STATE OF HAWAII
DEPARTMENT OF TRANSPORTATION
HIGHWAYS DIVISION
UTILITY PLAN
MAUNA KEA MAINTENANCE
BASEYARD
DANIEL K. INOUE HIGHWAY
Project No. 200A-01-10
Scale: As Shown Date: April, 2018

1	06-07-18	ADDENDUM NO. 4	
REVISION	DATE	DESCRIPTION	AA15

STATE OF HAWAII
DEPARTMENT OF TRANSPORTATION
HIGHWAYS DIVISION
SHOP BUILDING
MAUNA KEA MAINTENANCE BASEYARD
DANIEL K. INOUE HIGHWAY
Project No. 200A-01-10

EA1.1

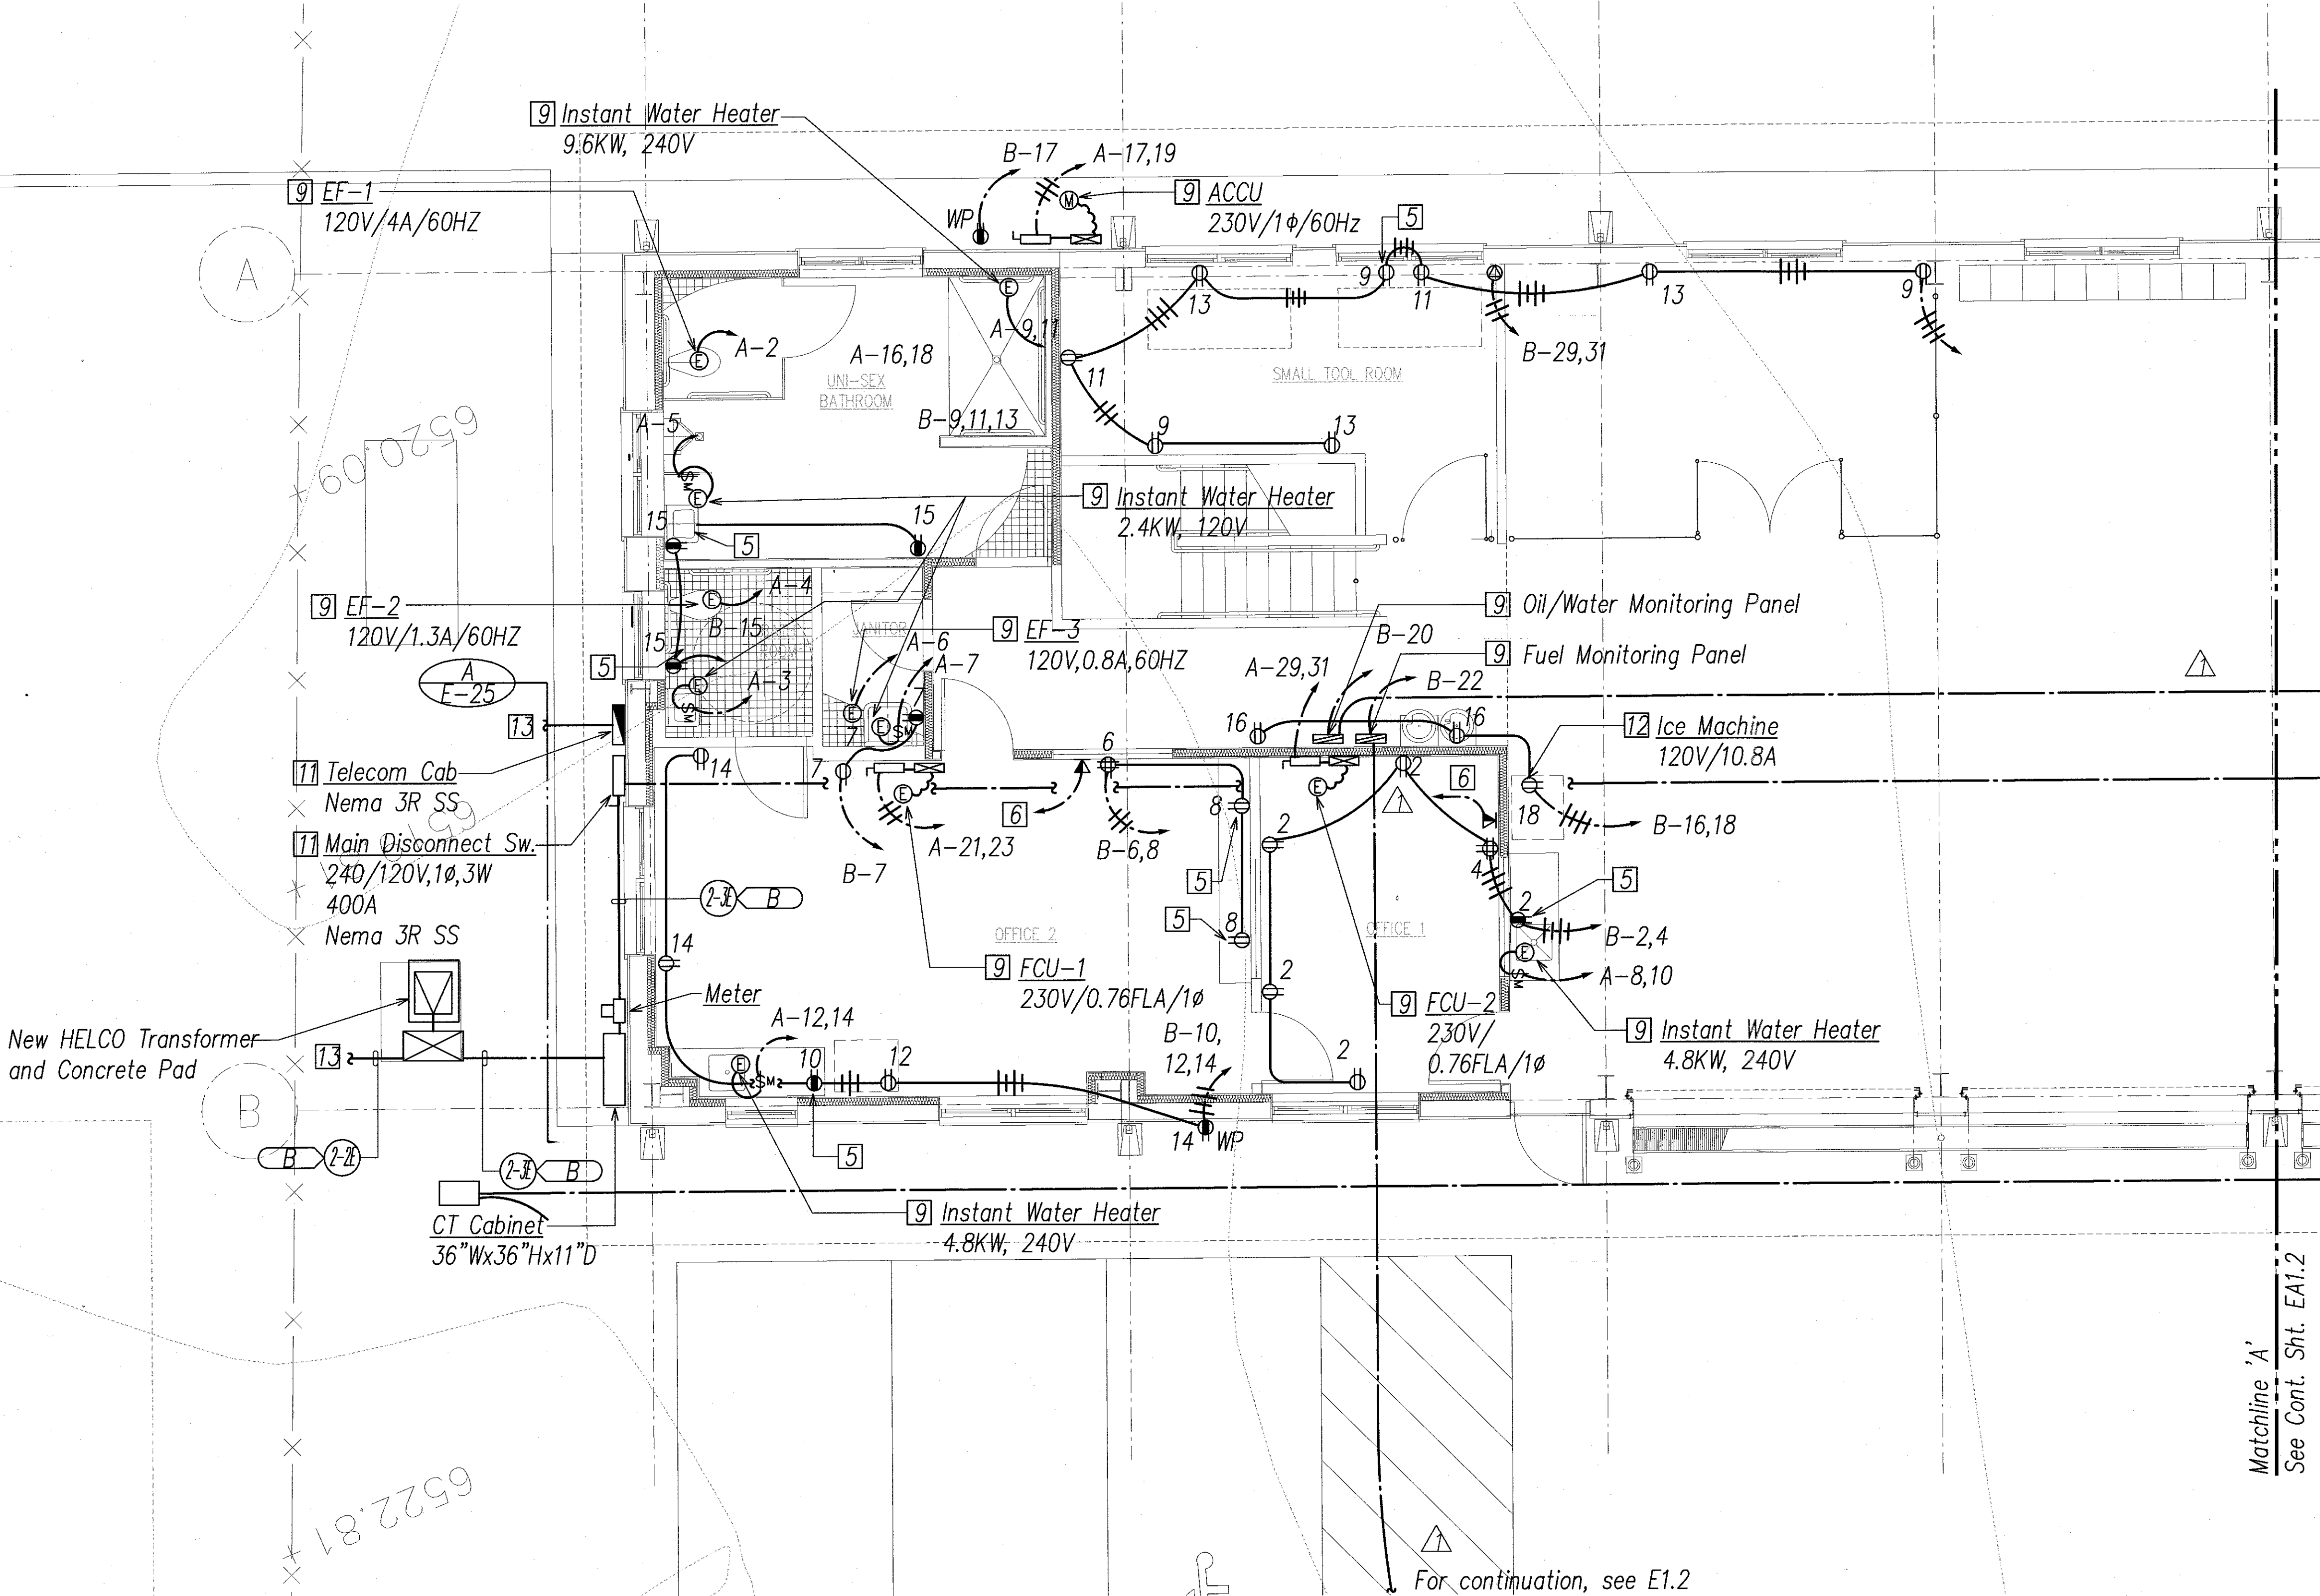
06-07-18 ADDED TELECOM DUCTLINES

EB1.1

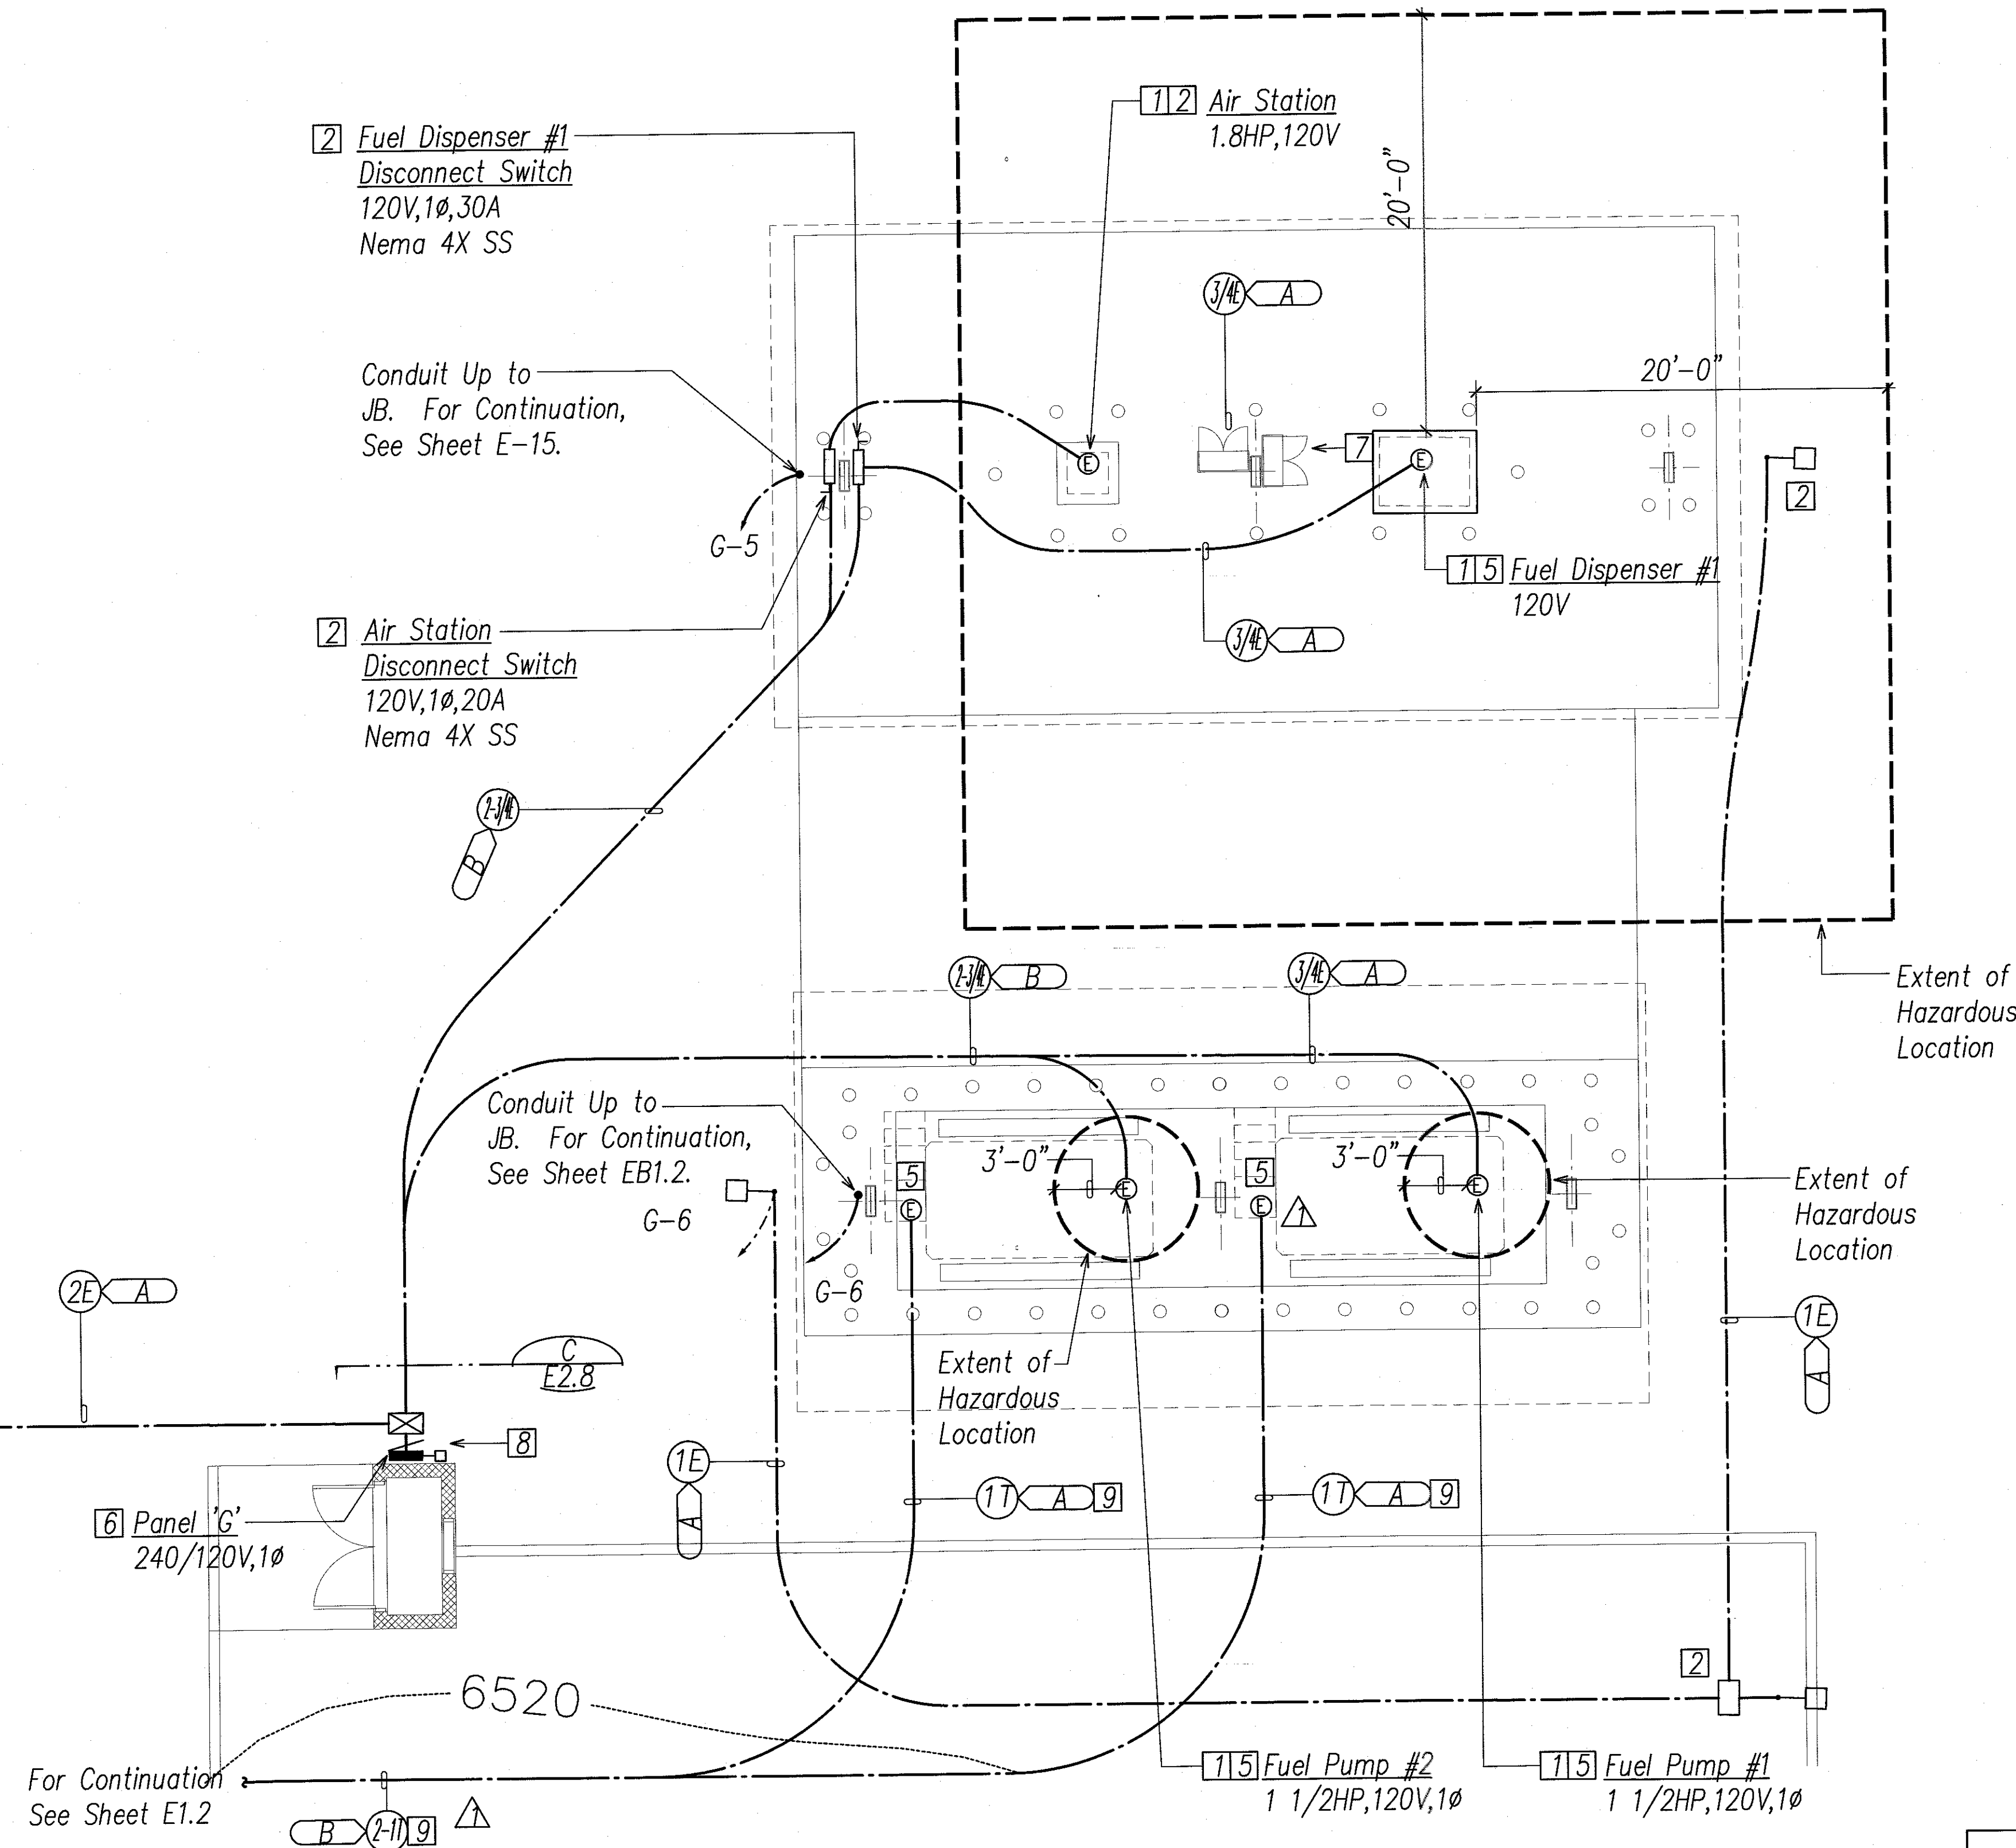
06-07-18	ADDED TELECOM DUCTLINES
DATE	REVISION
STATE OF HAWAII DEPARTMENT OF TRANSPORTATION HIGHWAYS DIVISION	
FUEL STATION	
MAUNA KEA MAINTENANCE BASEYARD	
DANIEL K. INOUE HIGHWAY Project No. 200A-01-10	
Scale: As Noted	Date: APRIL, 2018
